Re: Freeport-McMoRan Chino Mines Company –
Permit GR009RE Technical Comments on
Revision Application 18-1 for the Updated Closure Closeout Plan

Freeport-McMoRan Chino Mines Company (Cobre) submitted an update to Chino's Closure Closeout Plan (CCP) on February 14, 2018. The Mining and Minerals Department (MMD) in a letter dated June 18, 2018 requested Chino to respond to agency and public review comments. Where the comments included multiple questions within a paragraph, and in the hope that the response will be easier to track, the response is often located directly below the comment. The comments are listed in italics, followed by Chino's responses.

FIGURE
022A

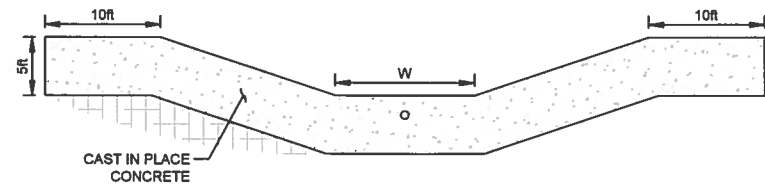
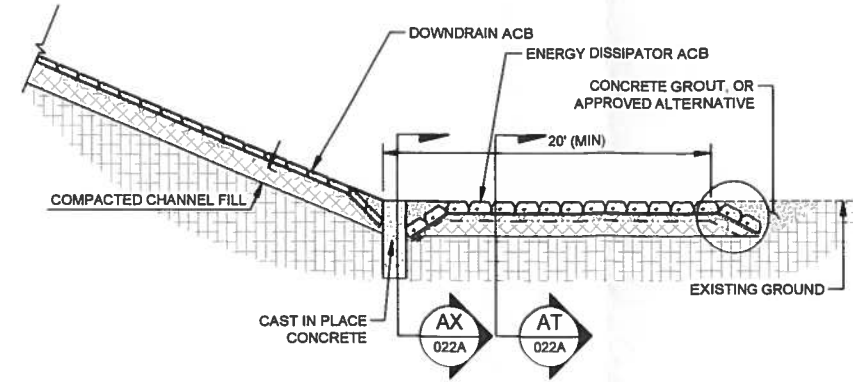
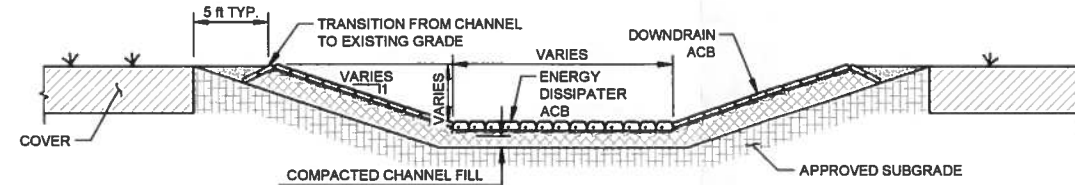
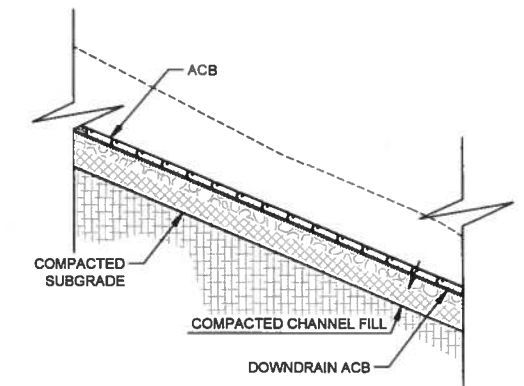
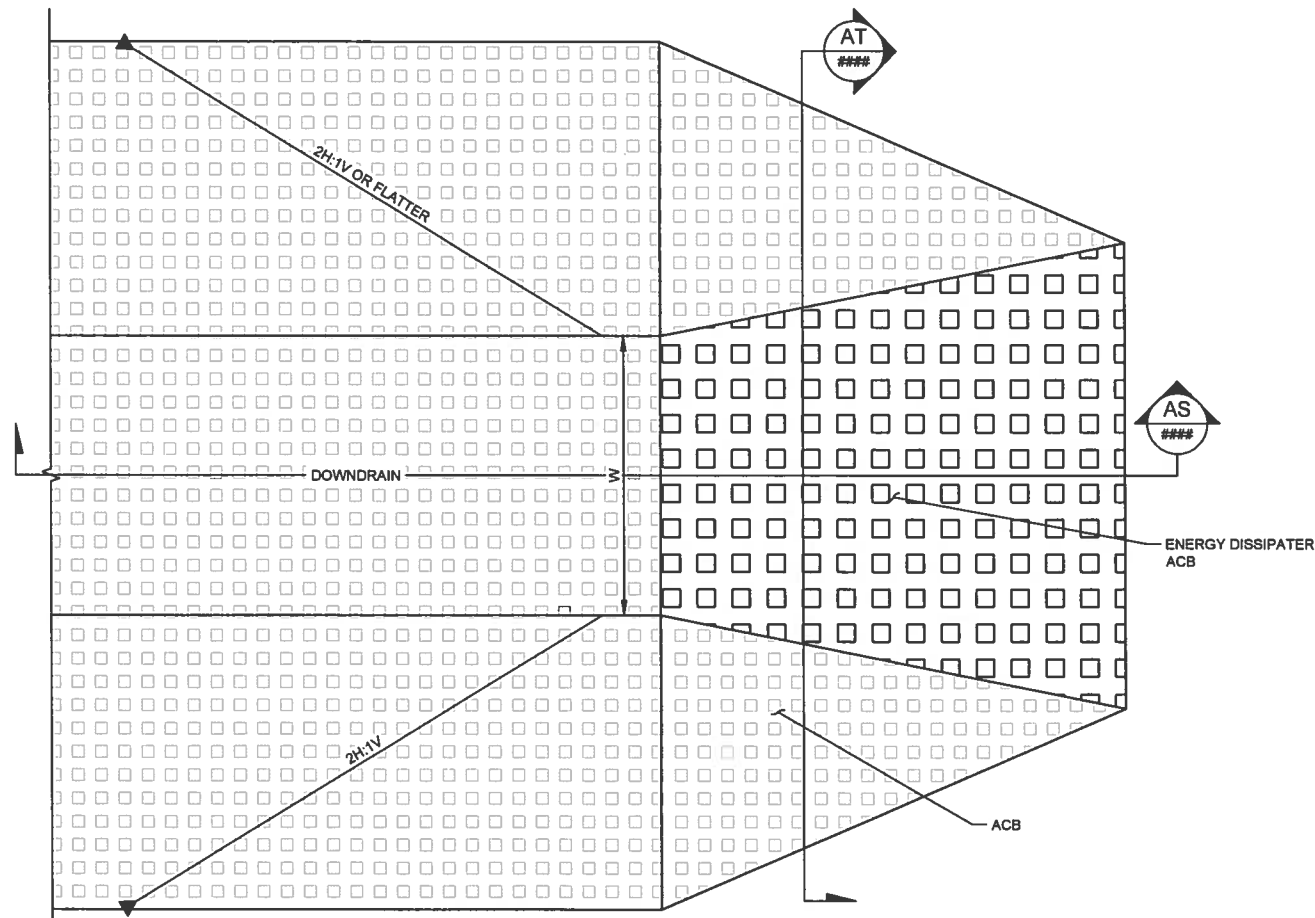
7. *Figure 022 in Appendix A - "Typical reclaimed outslope section" shows a toe collection feature. Please provide a typical design detail for the toe collection feature. Will toe channels require riprap? What is the approximate width and what storm event will the toe channels be designed to meet? Further, Chino should define areas in the Appendix A reclamation drawings where the toe channel will/will not be constructed for water conveyance since this will likely affect the cost estimate for construction.*

The toe collection feature depicted in detail 2/022 on Figure 022 in Appendix A - "Typical Reclaimed Outslope Section" was originally included in the reclamation drawing package in the 2007 CCP report and was inadvertently left in the 2018 Updated CCP report. Outside of the downdrain structures, runoff will be allowed to flow as sheet flow to natural ephemeral channels once the flow leaves the reclaimed facility. Detail 2/022 on Figure 022 in Appendix A has been revised to show the typical reclaimed outslope section for the areas outside the downdrains and is attached to this response letter. Toe energy dissipation structures will be constructed at the base of each downdrain structure. Typical details for the toe energy dissipation structures have been added to new Figure 022A in Appendix A and is attached to this response letter.

TITLE
**TAILING POND 6 EAST, 6 WEST AND 7 GRADING AND
 DRAINAGE PLAN**

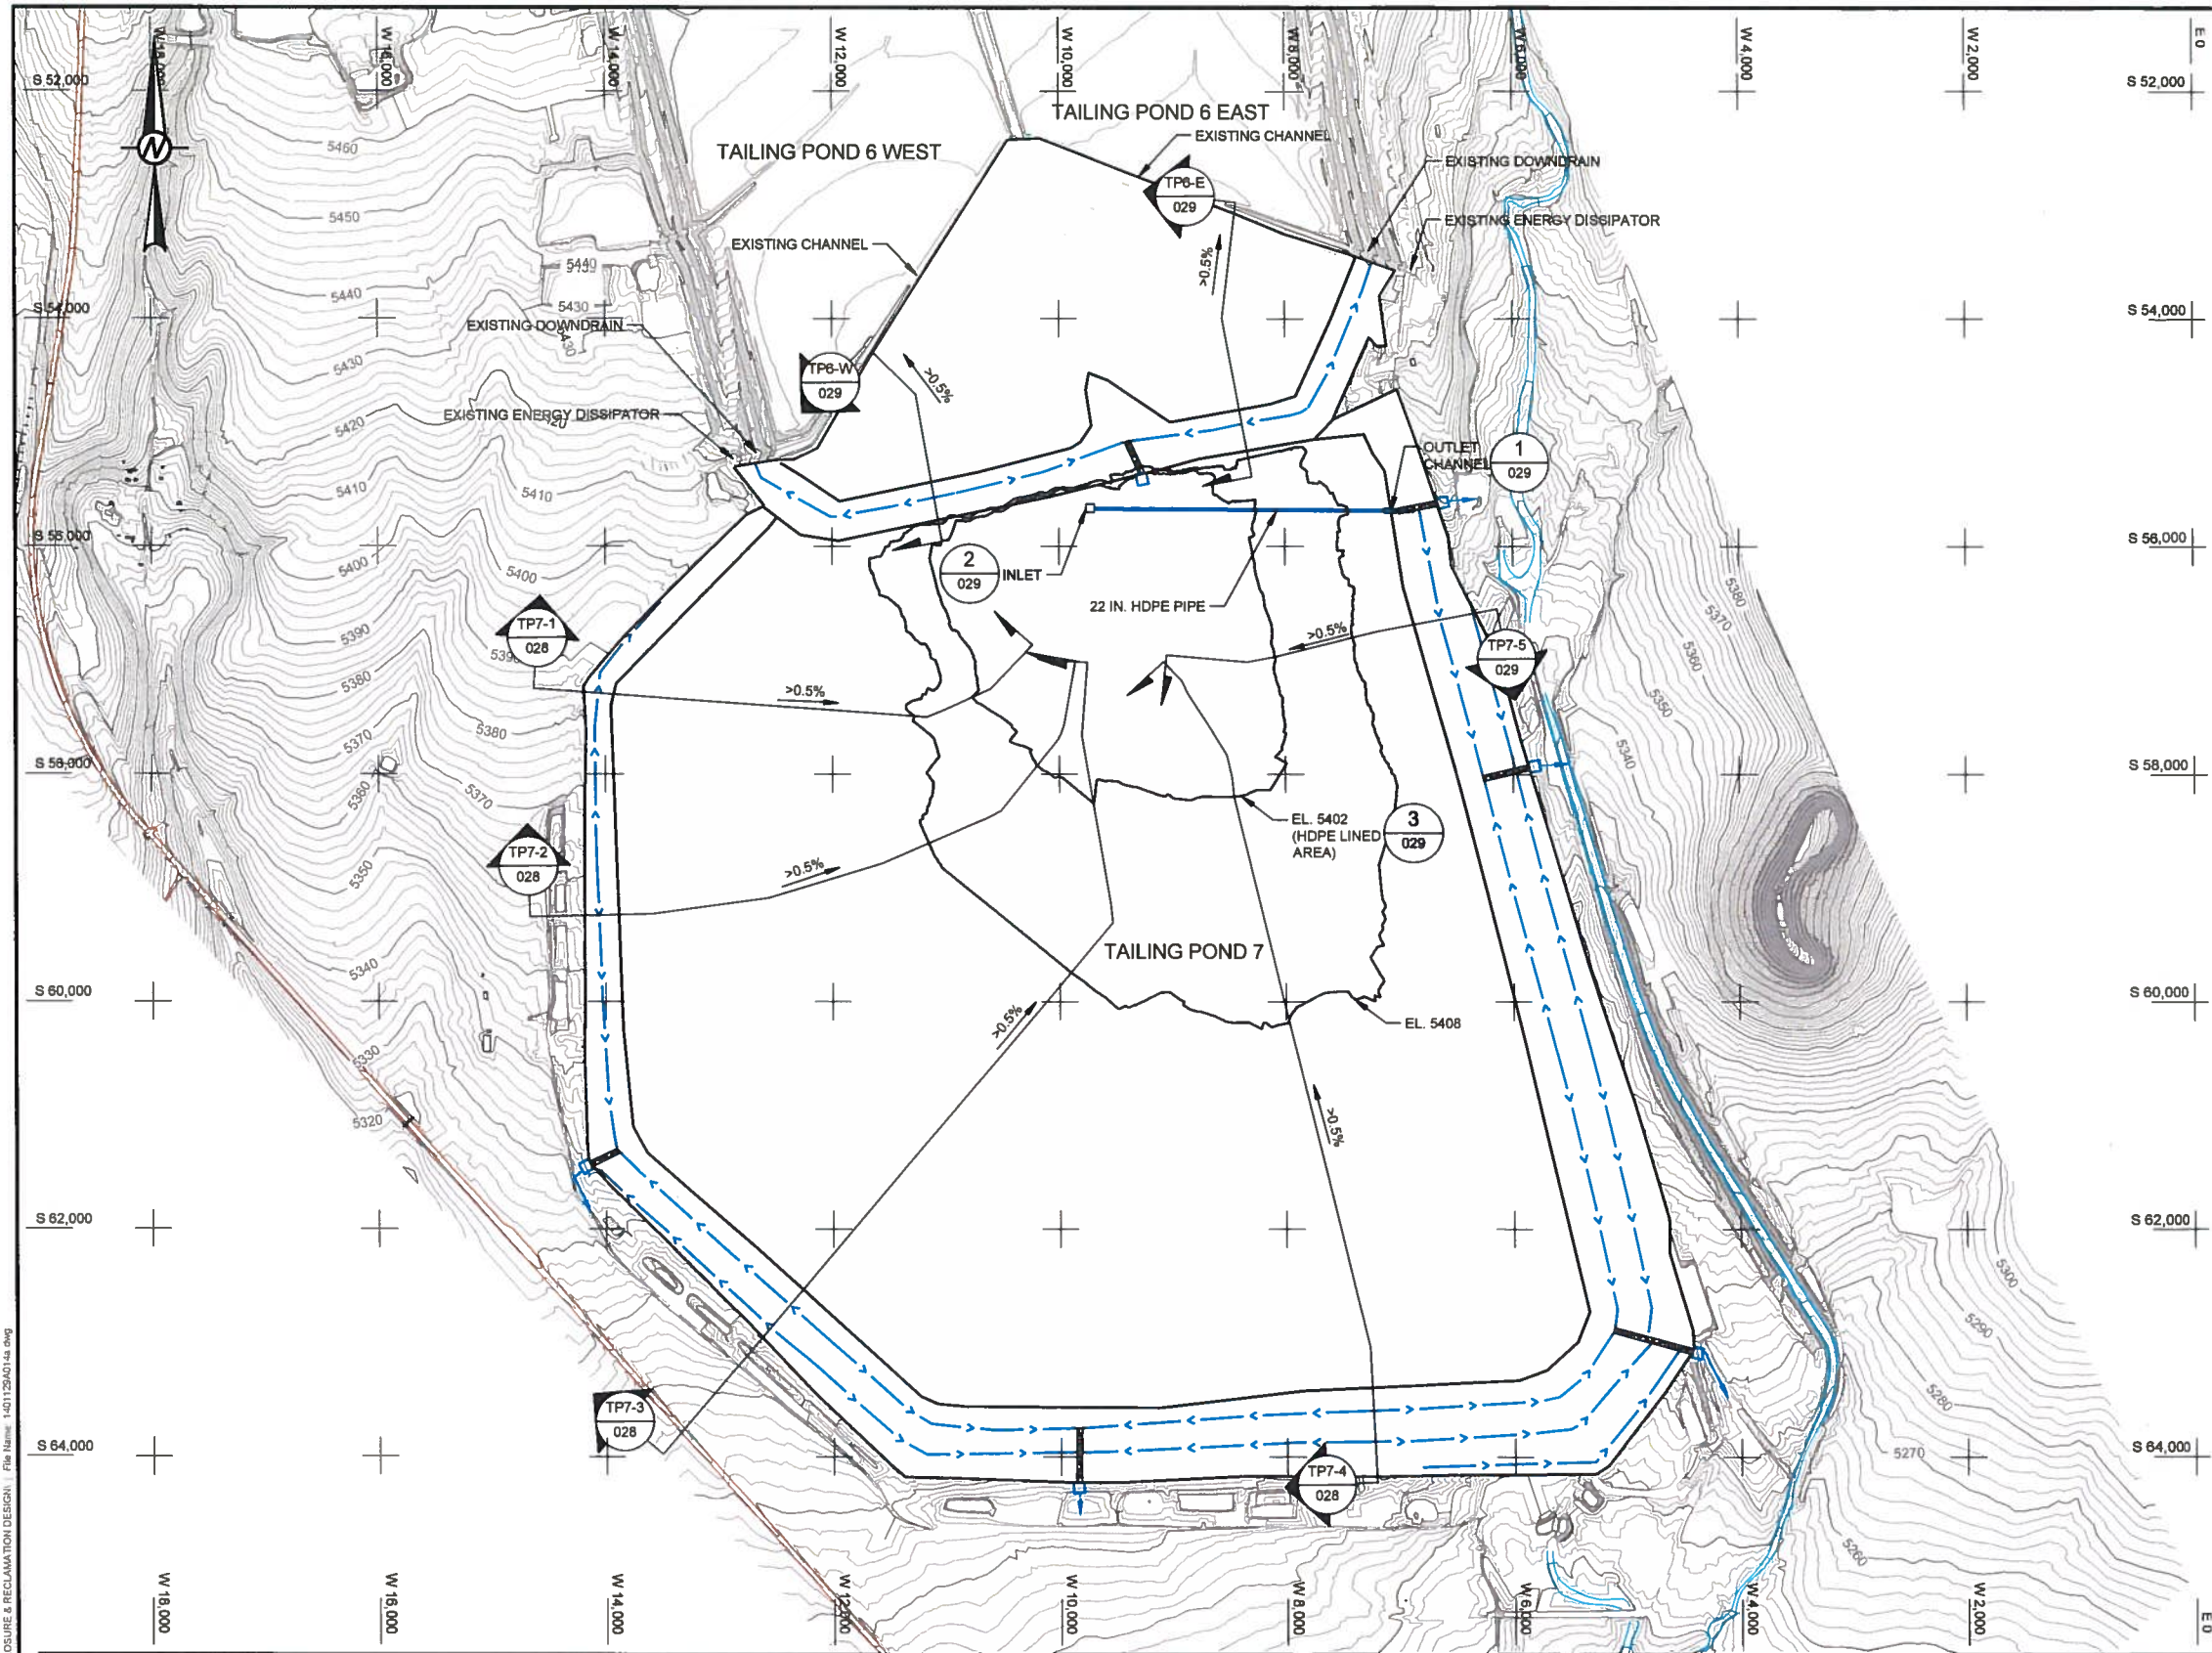
9. *Figure 027 should show the approximate aerial extent of the proposed HDPE geomembrane for the outlet channel at the NE corner of Tailing Pond 7. Additionally, please provide justification for two feet of cover over the HDPE geomembrane (see Figure 029) instead of three feet of cover proposed for the remainder of the impoundment.*

The primary purpose of the cover over the HDPE geomembrane is to provide an adequate seedbed for vegetation and have erosion resistant characteristics since the underlying geomembrane acts as an effective barrier to downward infiltration of meteoric water into the tailing material. In contrast, the three-foot cover being placed over tailing in the remaining impoundment area is designed as a store and release cover system capable of sustaining plant growth without continuous augmentation and has erosion resistant characteristics. Figure 027 in Appendix A has been updated to show the approximate aerial extent of the proposed HDPE geomembrane for the outlet channel at the NE corner of Tailing Pond 7 and is attached to this response letter.

TITLE
SOUTH MINE AREA BORROW AREAS & HAUL ROUTES

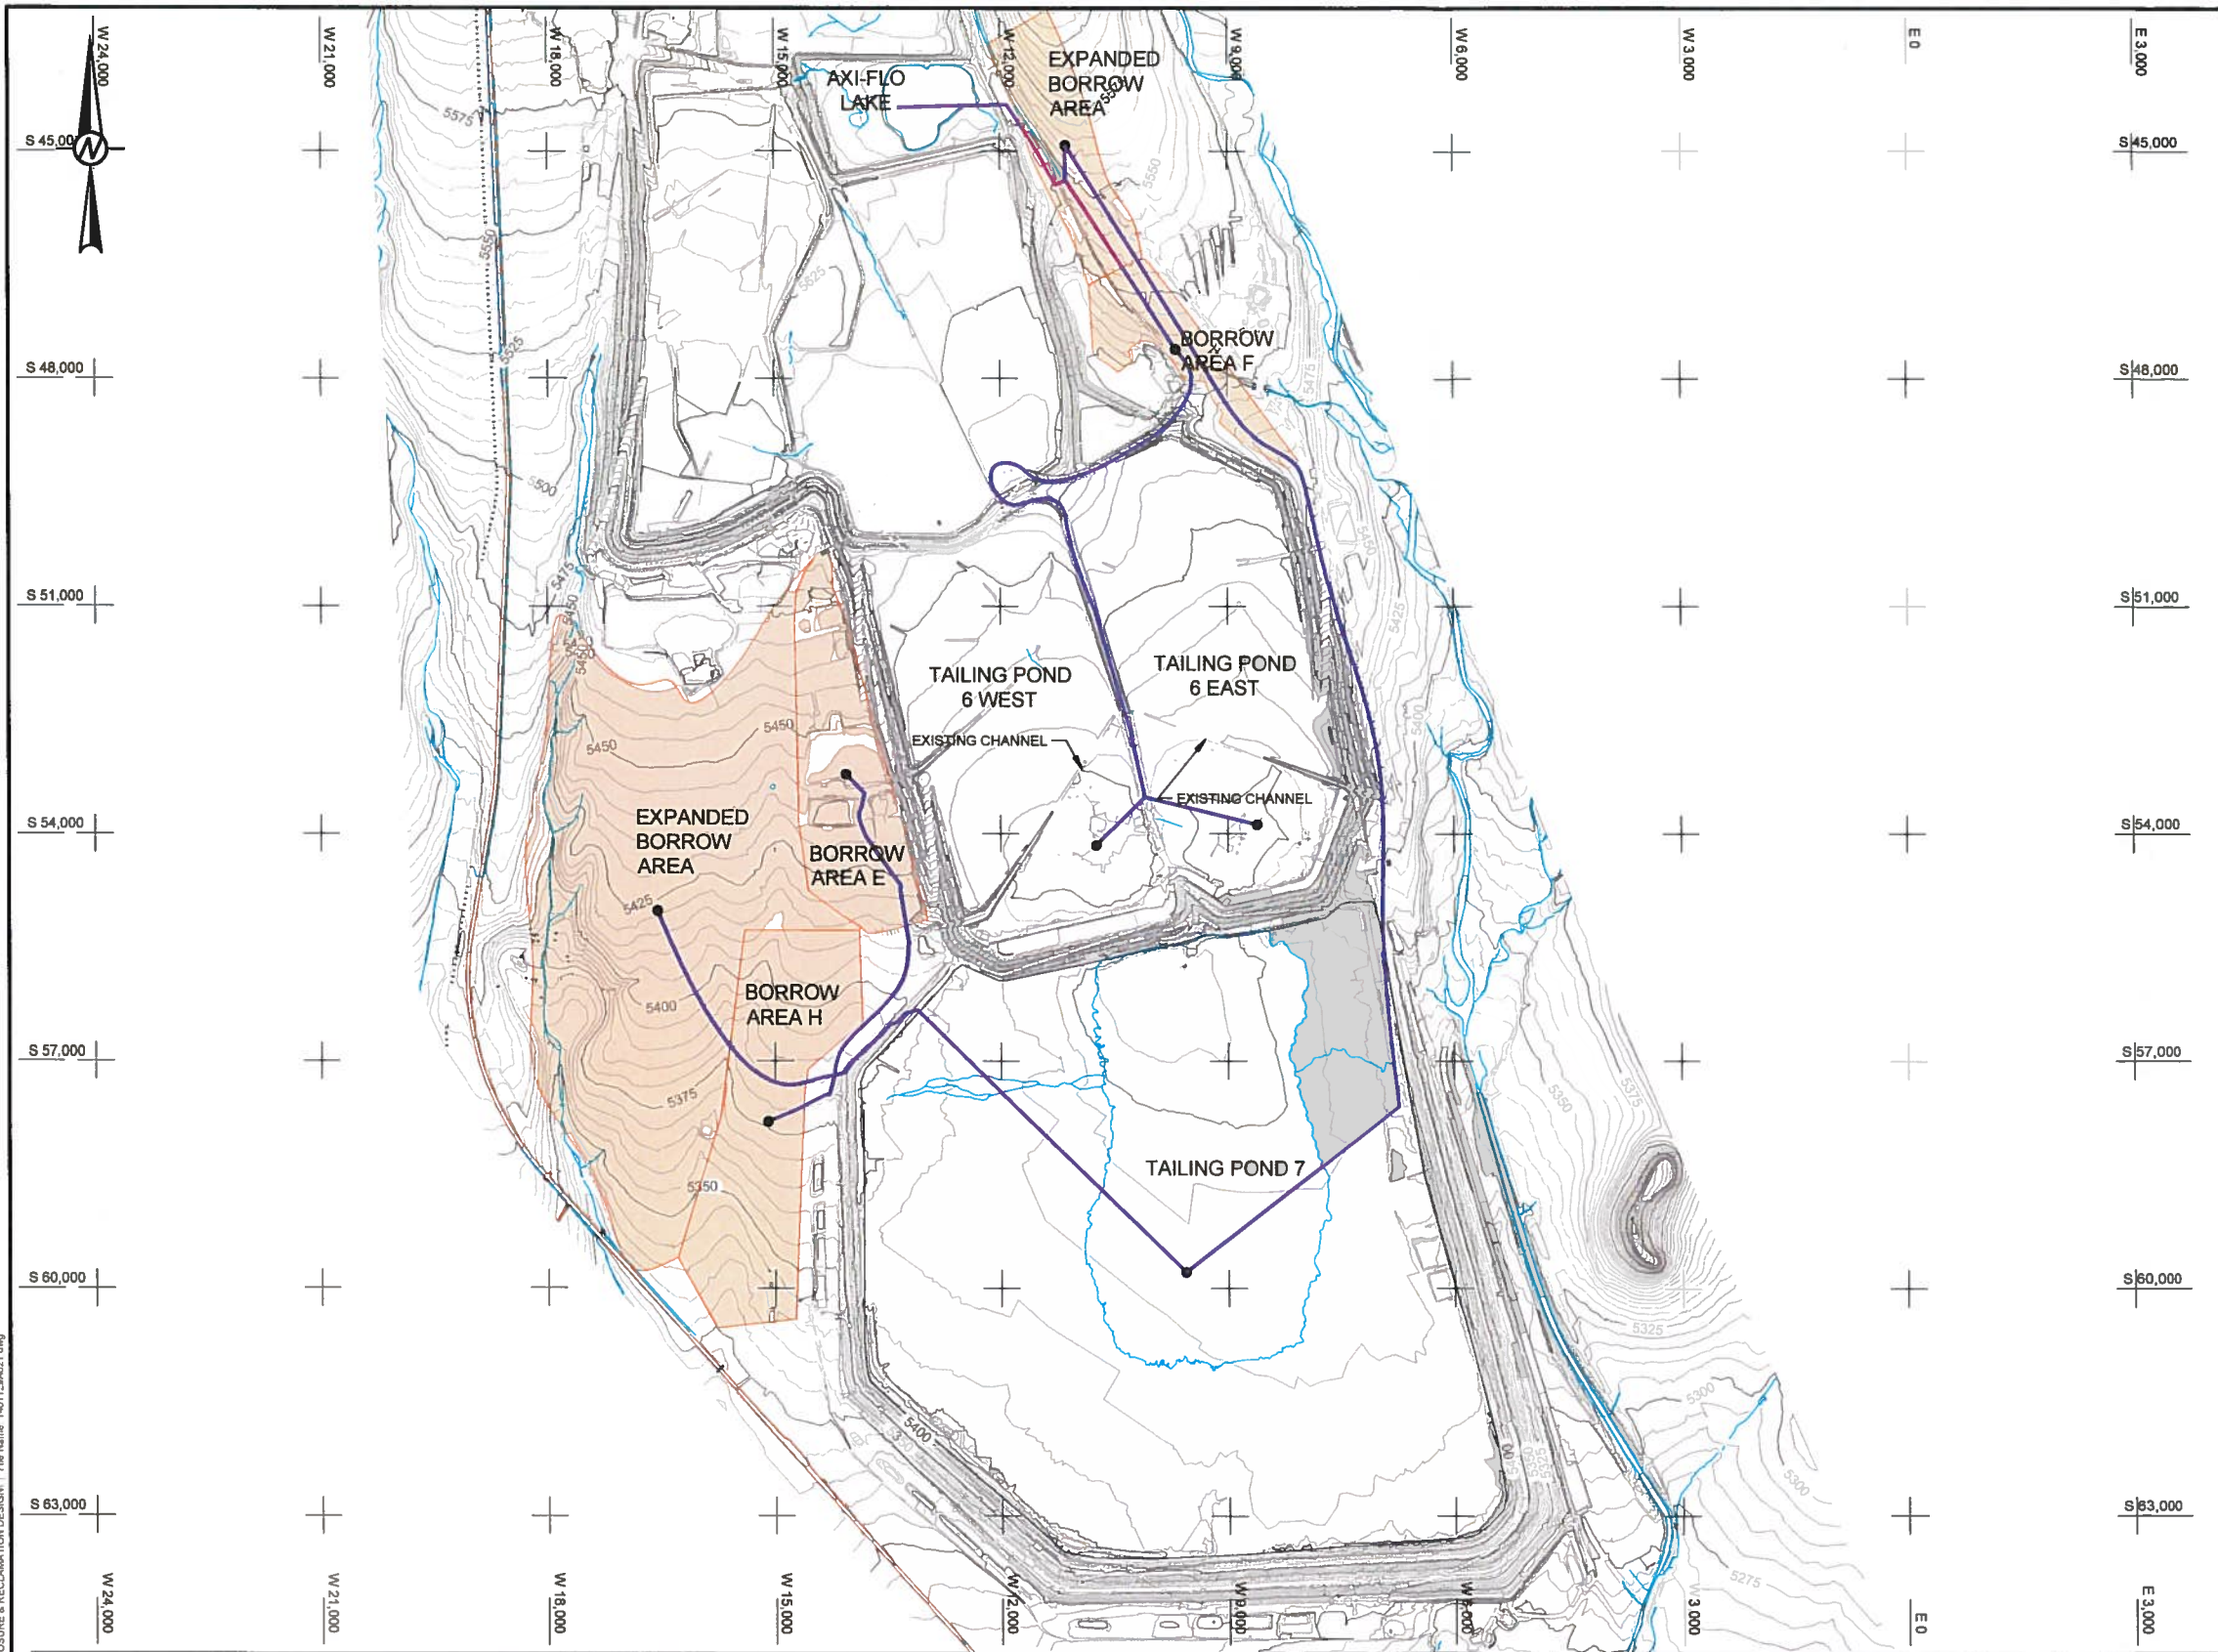
10. *Chino states on page 28, Section 3.3.8 and page 67 (earthwork material take-off summary table), that borrow material volume in borrow areas E, F and H is approximately 4 million yd³, while the earthwork take-off summary indicates a need for 9.77 million yd³ for the 2,019 acres yet to be reclaimed. Chino should clarify the volumetric discrepancy and indicate an anticipated reject percentage based on previous SMA reclamation using Gila Conglomerate. Additionally, Figure 030 shows borrow areas E and H located NW of Tailing Pond 7. These borrow areas could be affected by Chino's tentative plans to construct a new tailing pond in this area in the future. If/when a tailing impoundment is proposed, new borrow areas may need to be identified at that time.*

Results of previous borrow investigations in the South Mine Area (SMA) indicate that approximately 200,000,000 CY of potentially suitable borrow materials are present in the vicinity of the Chino Tailing Impoundments (DBS&A, 1998; Golder, 2006). The Gila Conglomerate and associated soils in the SMA have no inherent chemical limitations (DBS&A, 1998; Golder and URS, 2007b) and have proven to be suitable RCM for the reclaimed facilities in the SMA. A portion of the available borrow material in the SMA was utilized as part of the reclamation of Lake One; Older Tailings Ponds 1, 2, 4 East, 4 West, B, and C; and partial reclamation of older Tailings Ponds 6 East and 6 West. Remaining borrow areas E, F, and H will be utilized as the reclamation cover source for the remaining facilities within the SMA. These three borrow areas are estimated to contain over 4 million CY of suitable RCM. The area between Highway 180 and the western boundary of Borrow areas E and H shown on Figure 030 has been identified as an area containing suitable RCM and will be utilized for RCM in the SMA. The area to the north of Borrow Area F has also been identified as containing suitable cover material and will be utilized for RCM in the SMA. There are still substantial borrow material areas identified in the SMA that have not been utilized and are not included in this plan. The surplus of cover material available in the SMA will allow flexibility of configuring borrow areas, as well as providing for potential contingencies.

Attached Table 3 summarizes the RCM requirements for the SMA and the associated sources of the RCM for each facility to be reclaimed. As indicated in Table 3, approximately 9.773 MCYs of RCM is required for reclamation of the SMA. Table 4 presents the material balance for the SMA. As shown in this table, there is a projected excess of approximately 635,000 CYs of RCM in the borrow areas identified in this plan. Based on the substantial borrow material areas identified in the SMA that have not been utilized and are not included in this plan, no assumed reject percentage has been applied to the available RCM volumes. Figure 030 in Appendix A, Section 3.3.8, and the earthwork material take-off summary table on page 67 of the CCP will be updated to reflect these changes. Updated Figure 030 has been revised to show the updated haul routes depicted on the figure and is attached to this response letter.
